Greater-Than-Class-C Low-Level Radioactive Waste EIS Draft Comment: GTCC10121

Appendix J: Comment Response Document

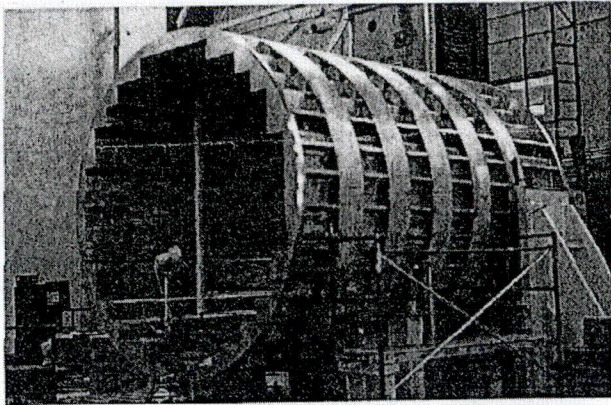
I have enclosed a photograph of a typical, new, unirradiated baffle/shroud. The approximate dimensions of this component, which is a fully welded structure, are of the order of 14 feet long and 12 feet in diameter. The baffle/shroud from a PWR is likely to contain millions of curies. The Maine Yankee shroud contained approximately 2 million curies after 25 years of operation.

In addition, for those plants that have already packaged GTCC waste into canisters licensed for rail transport, the EIS does not contain any analysis of the advantages or disadvantages of constructing a facility that could support the necessary segmentation and packaging that would be required to transfer this waste to AMC-sized containers.
